**Re: Further Site Investigation Work Plan
Former Troy Laundry & Cleaners
320 Pine Street, Sheboygan Falls, Wisconsin
BRRTS#: 02-60-385641**

Subject: Response to May 2017 Site Investigation Report
Troy Laundry & Cleaners, 320 Pine St., Sheboygan Falls, Sheboygan County, WI
DNR BRRTS Activity #: 02-60-385641

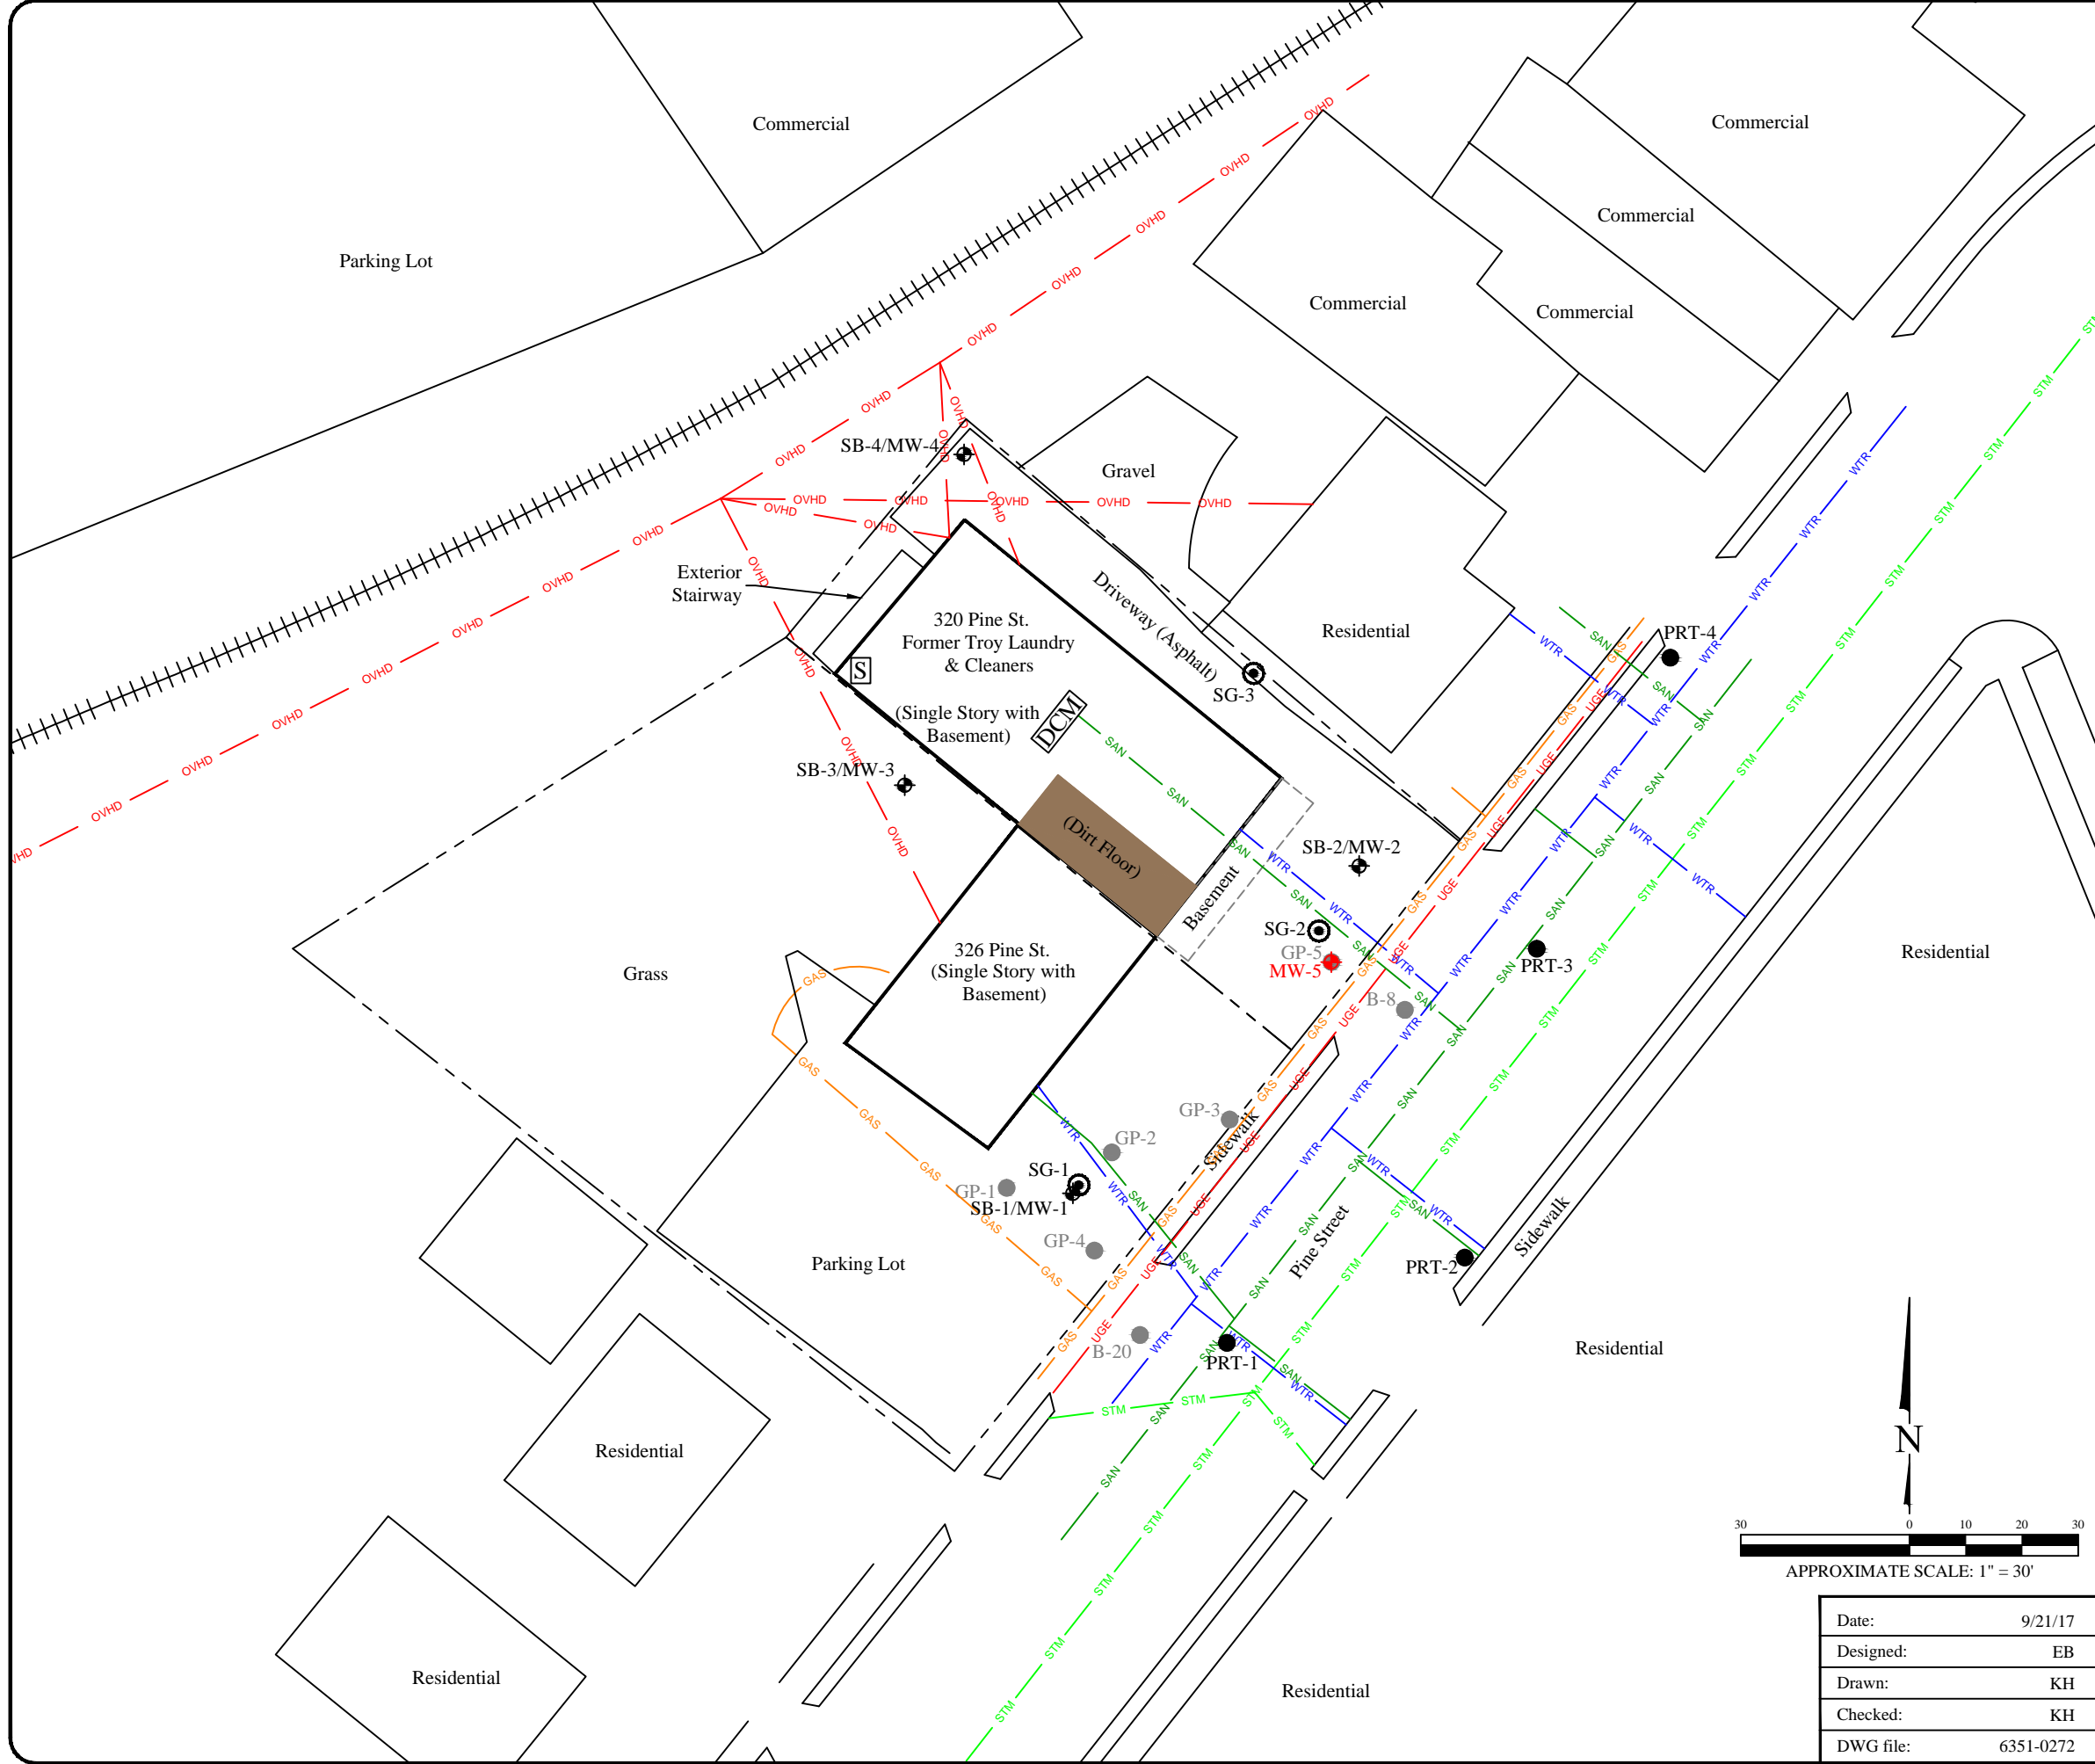
1. Tetrachloroethylene ("PCE") contamination in groundwater identified in grab samples collected from borings GP-5 and B-8 (see attached Figure 2 – Site Layout) have not been verified or collected from a monitoring well that was constructed in accordance with ch. NR 141, Wis. Adm. Code as required under s. NR 726.05(7)(c), Wis. Adm. Code. An additional monitoring well needs to be installed in the vicinity of boring GP-5 to assess contamination concentrations and trends near the source area. Based on the groundwater analytical results obtained from this monitoring well, additional monitoring points maybe required to define the extent of groundwater contamination to the southeast and/or along utility lines.

A new monitoring well designated MW-5 will be installed at the location of former soil boring GP-5 (see **Figure 2**). The purpose of MW-5 is to evaluate groundwater conditions at the GP-5 location with a permanent monitoring well constructed in compliance with WDNR regulations. The well will be installed using hollow-stem auger methods in accordance with the requirements of Wisconsin Administrative Code (WAC) Chapter NR 141. A boring log will be generated but soil samples will not be collected from the boring. The monitoring well will be constructed with a 10-foot long 0.010-inch slotted screen from approximately 8 to 18 feet below ground surface (bgs). Well materials will be 2-inch diameter PVC. An expandable locking cap and padlock will be placed on the well. The surface completion will consist of a flush-mount well vault set in concrete. The new monitoring well will be developed according to the procedures described in WAC Chapter NR 141.

VAPOR INTRUSION ASSESSMENT SAMPLE LOCATIONS

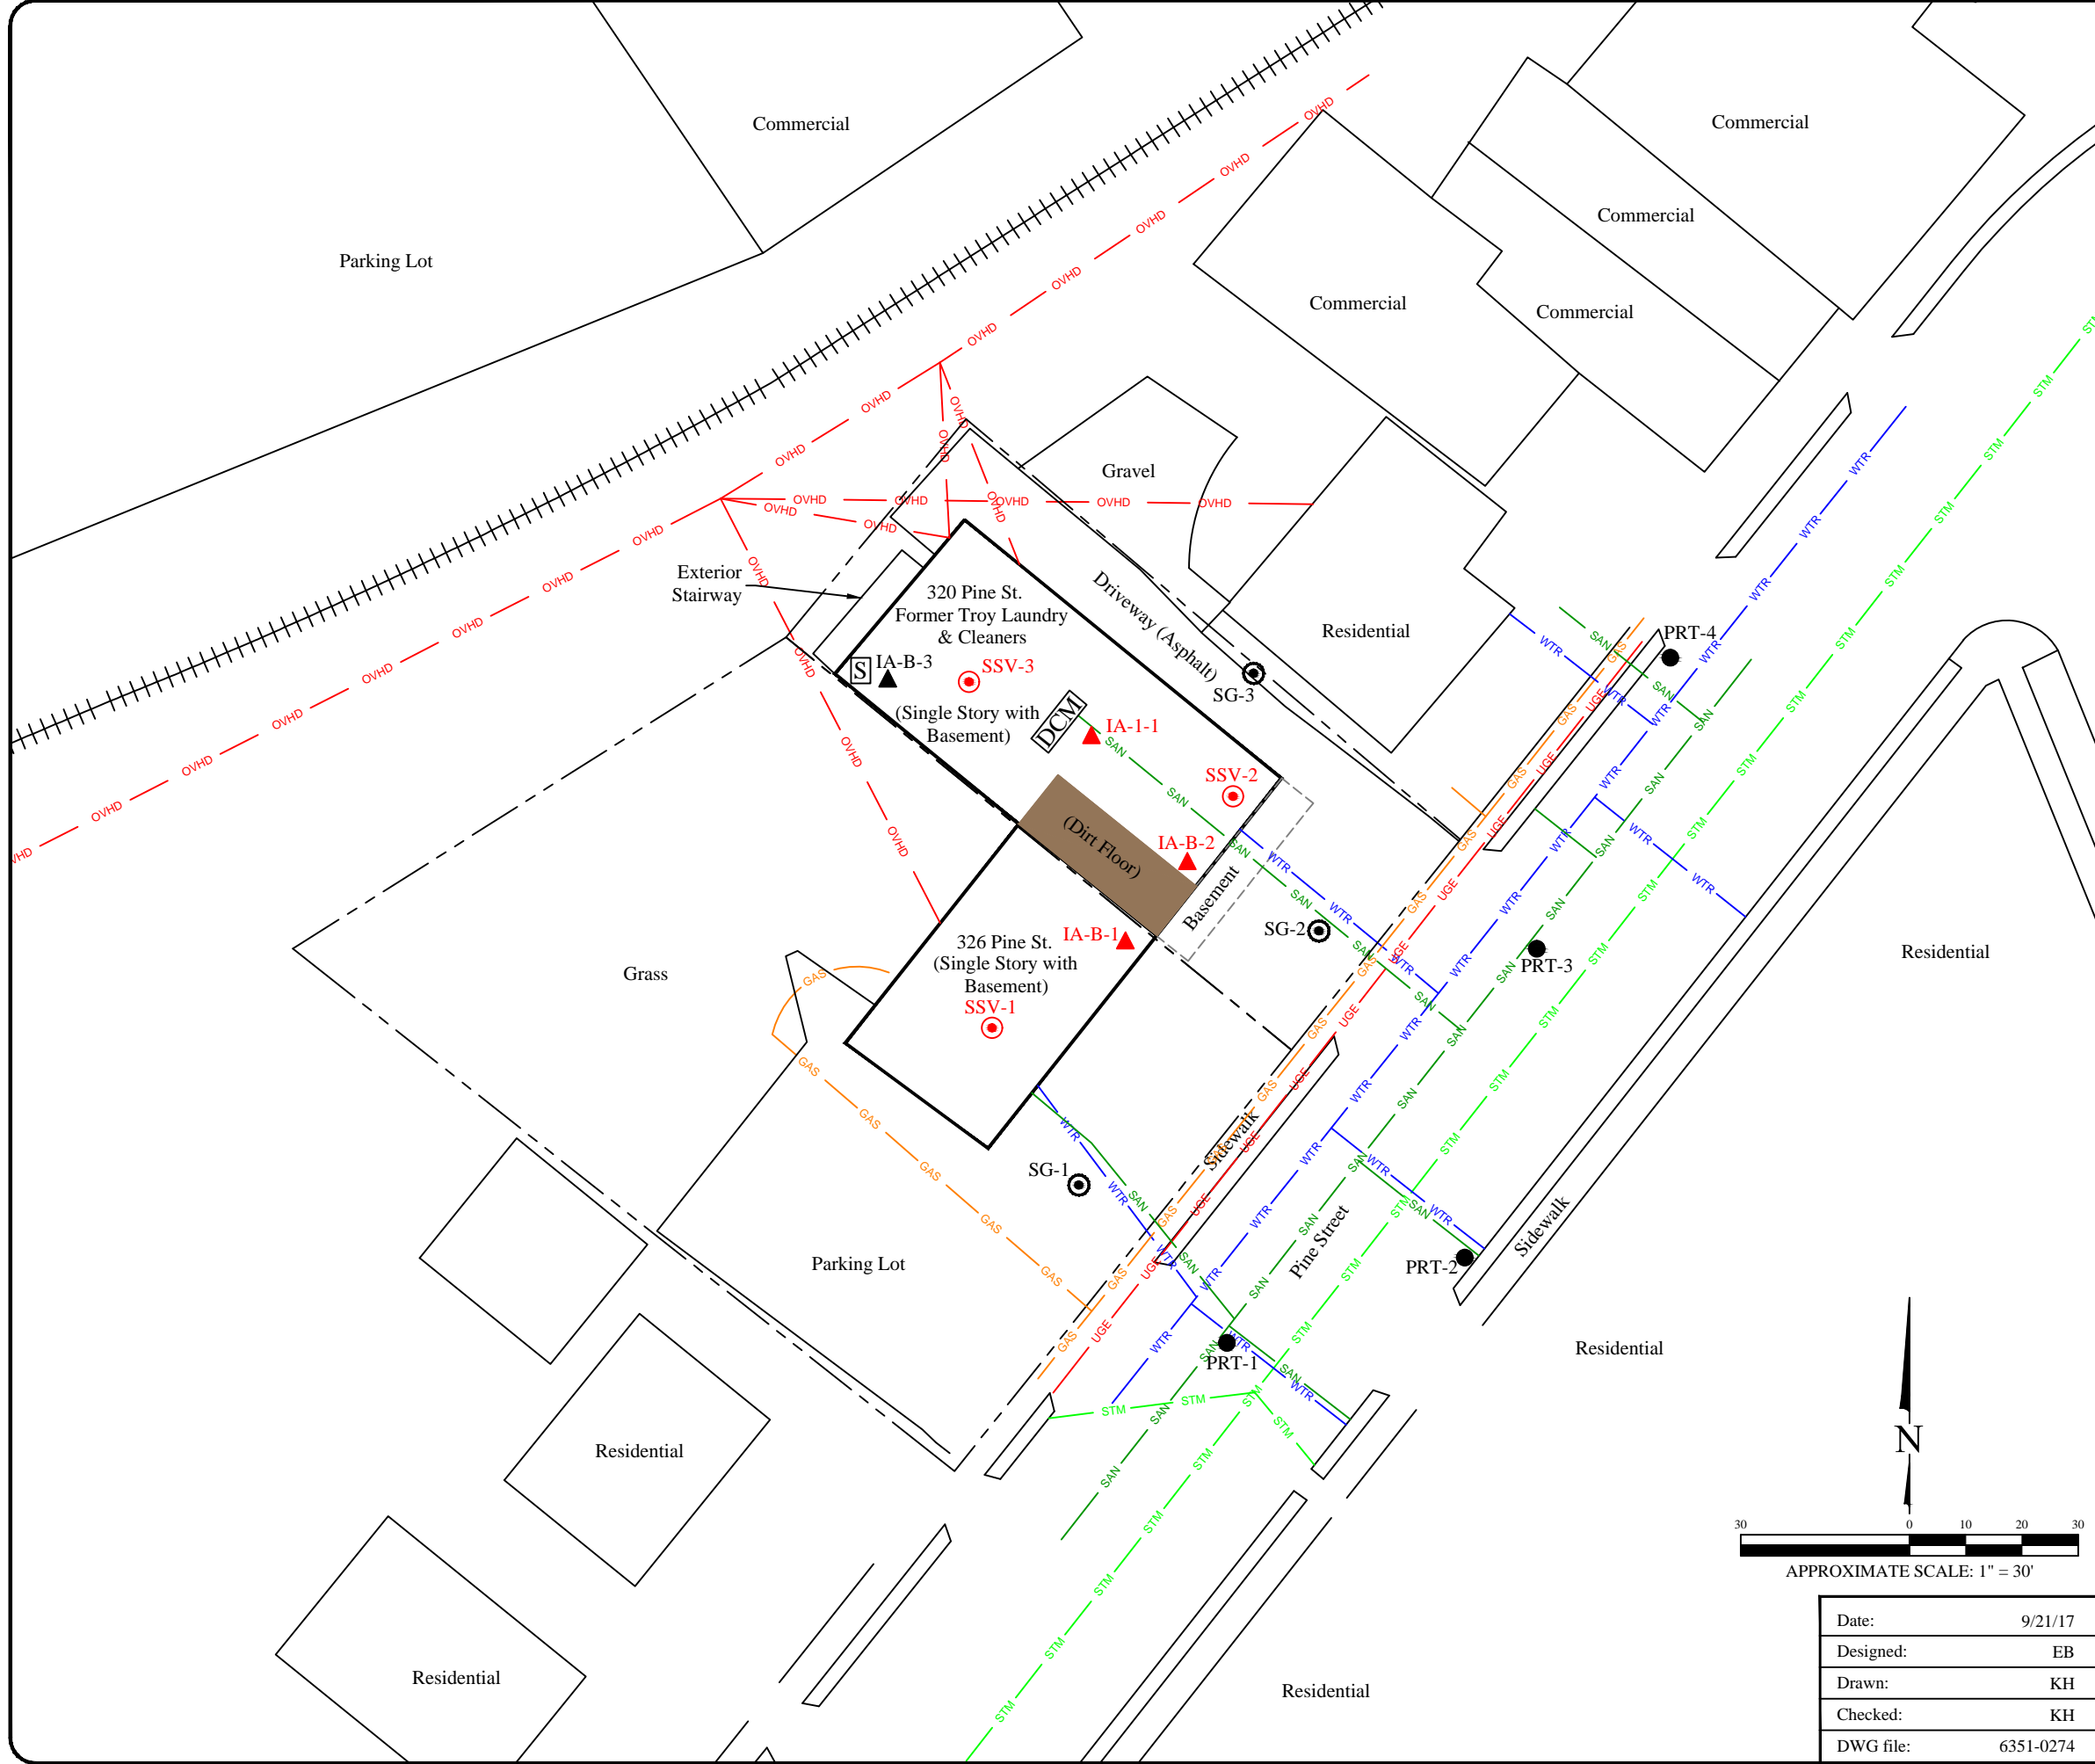
2. Additional investigation to assess the vapor intrusion pathway is needed to characterize the degree and extent of contaminated vapor directly beneath the building per the requirements of s. NR 716.11(3)(a), Wis. Adm. Code. The vapor intrusion pathway cannot be ruled out based on indoor air samples alone. The PCE concentration measured in soil gas at SG-2 and the likelihood contaminated groundwater is in contact with the building foundation both support the need for additional vapor sampling. A soil gas sampling port and two sub-slab vapor ports are needed to assess vapors beneath the building based on the layout and construction of the inter-connected buildings shown on Figure 2 – Site Layout. The soil gas sampling port needs to be installed within the unfinished floor (i.e., dirt) of the basement. One sub-slab vapor port is needed within the footprint of the single story slab on-grade portion of the building and the second sub-slab vapor port is needed beneath the concrete floor from within the footprint of the basement. A minimum of two

vapor sampling events is needed to adequately assess the potential for contaminant vapors to migrate into the breathing space of the buildings. At least one event should be collected under frost conditions while the heat is running. Resources including fact sheets, videos and template letters are available to assist in gaining access and communicating vapor results to occupants at the following website: <http://dnr.wi.gov/topic/Brownfields/Vapor.html>.

The vapor intrusion (VI) assessment will include indoor air and sub-slab vapor sampling. Two (2) sampling events will be performed with at least one (1) event during the winter months. Three (3) sub-slab vapor samples and three (3) indoor air samples will be collected during each event. The proposed sample locations are depicted on **Figure 3**. All VI assessment activities will be conducted in accordance with WDNR guidance, including Publication RR-800: *Addressing Vapor Intrusion at Remediation & Redevelopment Sites in Wisconsin*.

Permanent Vapor Pin[®] sampling ports will be installed in the basement slab of the building. Previous documents had indicated that the southwest part of the building was slab-on-grade construction. A slab-on-grade part of the building is also referenced in the WDNR letter (**Attachment 1**). However, a basement exists under the entire Site building.

The proposed sampling port locations are depicted on **Figure 3**. The sampling ports will be capped during installation until sampling is initiated. To ensure that the sub-slab vapor samples are representative of subsurface conditions, water dam leak testing will be performed at each
